DART AEROSPACE LTD	Work Order:	75785
Description: Crosstube Assembly (412 High Aft)	Part Number:	D412-664-243
Inspection Dwg: D412-664-243 Rev: E		Page 1 of 1

DART AEROSPACE LTD HAWKESBURY, ONTARIO, CANADA	
DRAWING NO. D412-664-243	REV. E SHEET 1 OF 4
TITLE CROSSTUBE ASSEMBLY (412 HI AFT)	SCALE NTS
COPYRIGHT © 2001 BY DART AEROSPACE LTD THIS DOCUMENT IS PRIVATE AND CONFIDENTIAL, AND IS SUPPLIED ON THE EXPRESS CONDITION THAT IT IS NOT TO BE USED FOR ANY PURPOSE OR COPIED OR COMMUNICATED TO ANY OTHER PERSON WITHOUT WRITTEN PERMISSION FROM DART AEROSPACE LTD.

DRAWING NO. D412-664-243	TITLE CROSSTUBE ASSEMBLY (412 HI AFT)	REV. E	DART AEROSPACE LTD ENGINEERING ORDER		D.E.O. NO. D412-664-243-E-1	SHEET NO. SHEET 1 OF 2	SCALE NTS
DRAWN	CHECKED	MFG. APPR.	APPROVED	DE APPR.			
DATE 11.03.31	DATE 11/03.31	DATE 11.03.31	DATE 11/03.31	DATE 11.03.31

DRAWING NO. D412-664-243	TITLE CROSSTUBE ASS'Y (412 HI AFT)	REV. E	DART AEROSPACE LTD ENGINEERING ORDER		D.E.O. NO. D412-664-243-E-2	SHEET NO. SHEET 1 OF 1	SCALE NTS
DRAWN <i>qp</i>	CHECKED <i>ASS</i>	MFG. APPR. <i>EE</i>	APPROVED <i>MP</i>		DE APPR. <i>MP</i>		
DATE 11.09.07	DATE 11.09.19	DATE 11.09.19	DATE 11.09.19		DATE 11.09.19

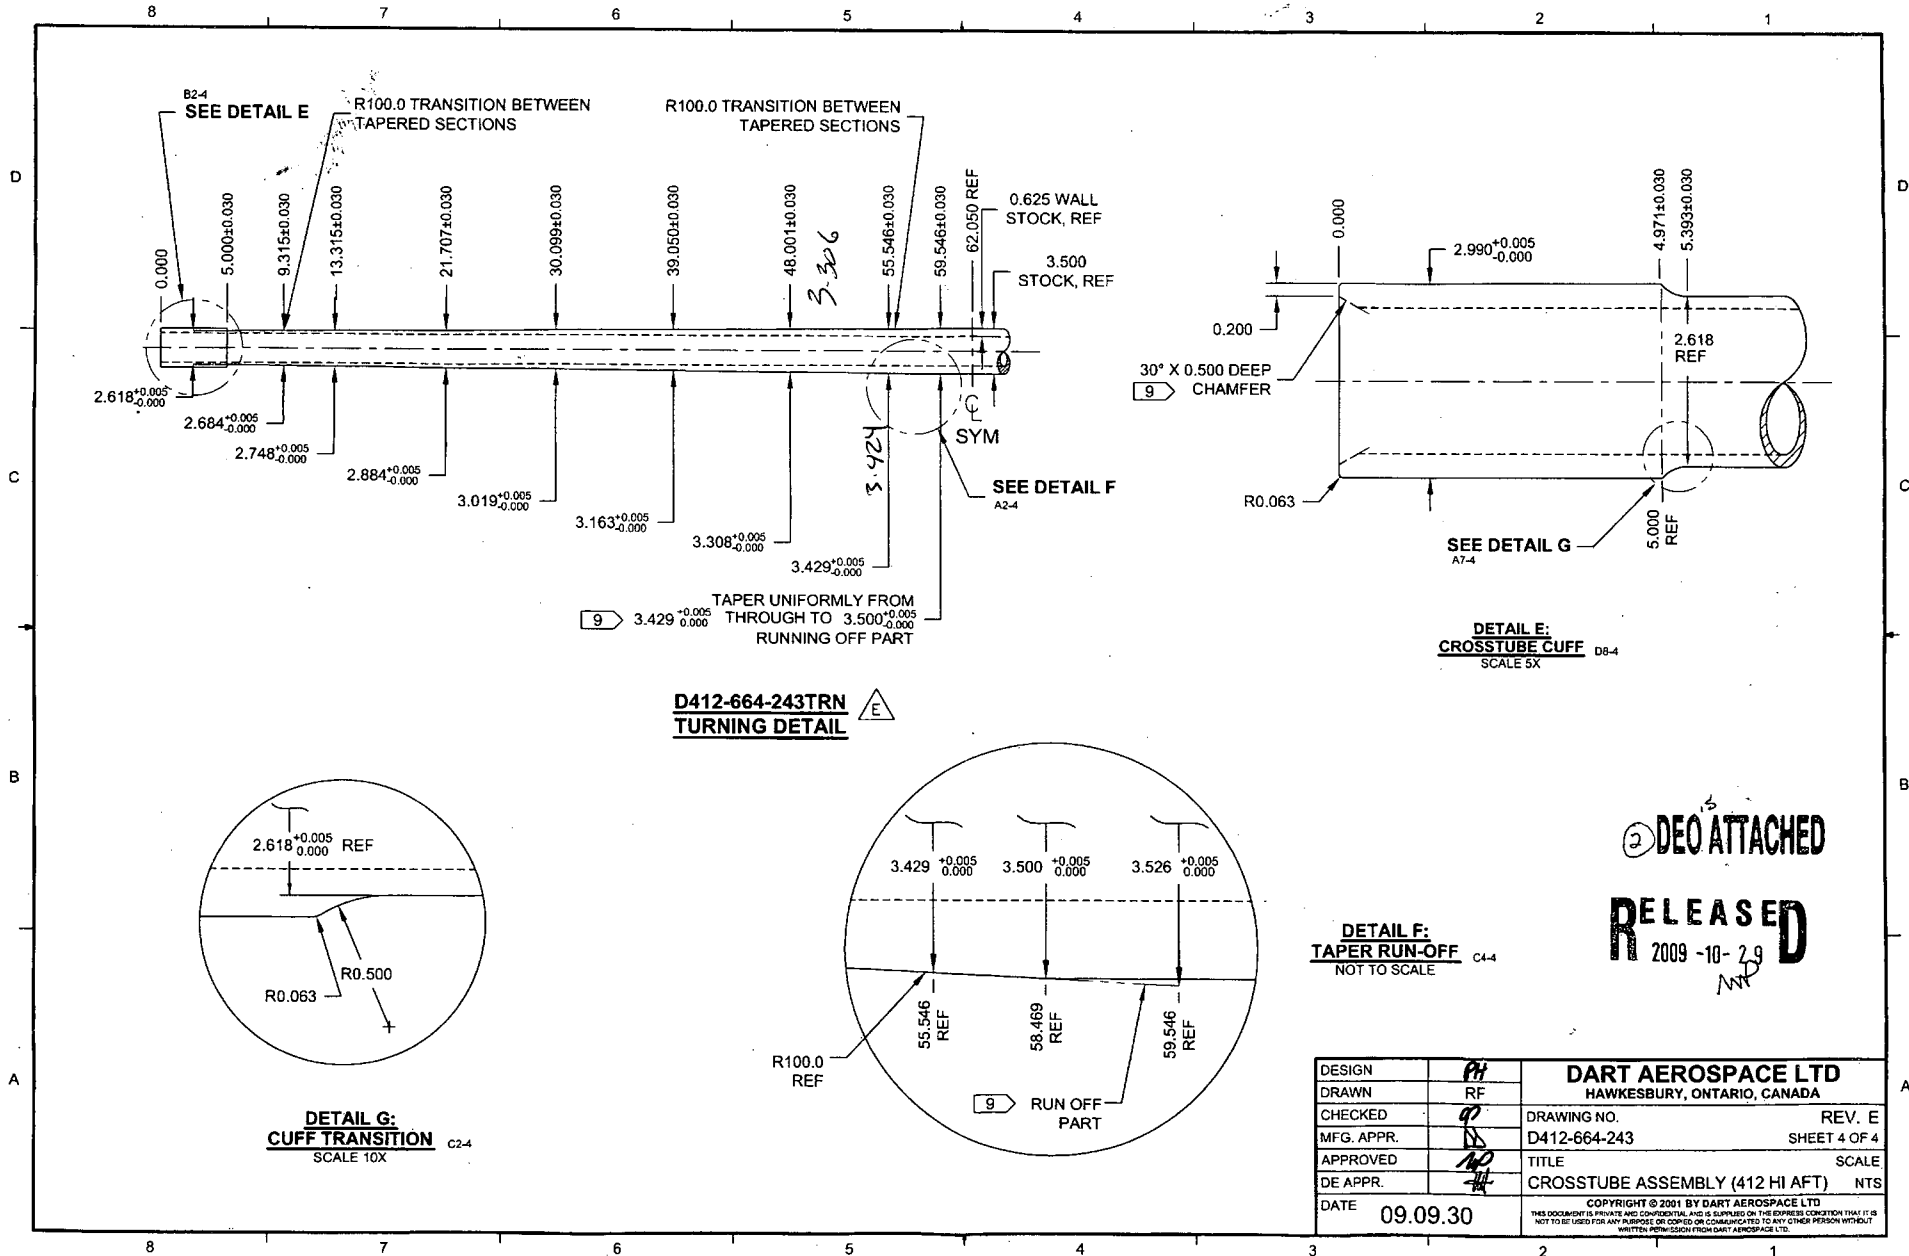
NCR:		WORK ORDER NON-CONFORMANCE (NCR)						
DATE	STEP	Description of NC Section A	Corrective Action Section B			Verification Section C	Approval Chief Eng	Approval QC Inspector
			Initial Chief Eng	Action Description Chief Eng	Sign & Date			
11/11/06	100	Undercut on tube OD undercut is at 51"-58" From cald. Rousting still visible at that length. R.I. LOA Overall error	<u>11/11/07</u> <u>051042</u>	→ measure at 48.00" → 3.306" (-0.002" under normal) 55.846 → 3.424" (-0.005" under normal + Rousting shows)	<u>7</u>	<u>7</u>	<u>11/11/07</u> <u>051042</u>	<u>11/11/07</u>
		Direct Key in all set correctly (Dry is good, Rai is good, Polygon) good correct <u>LOA</u>		→ Scrap tube. 412 Aft these are critical in fatigue. Can't justify going below tolerance in this area. <u>11.11.07</u>	<u>11-11-08</u>	<u>SAD</u> <u>11-11-08</u>		<u>11/11/07</u>
				no Replze
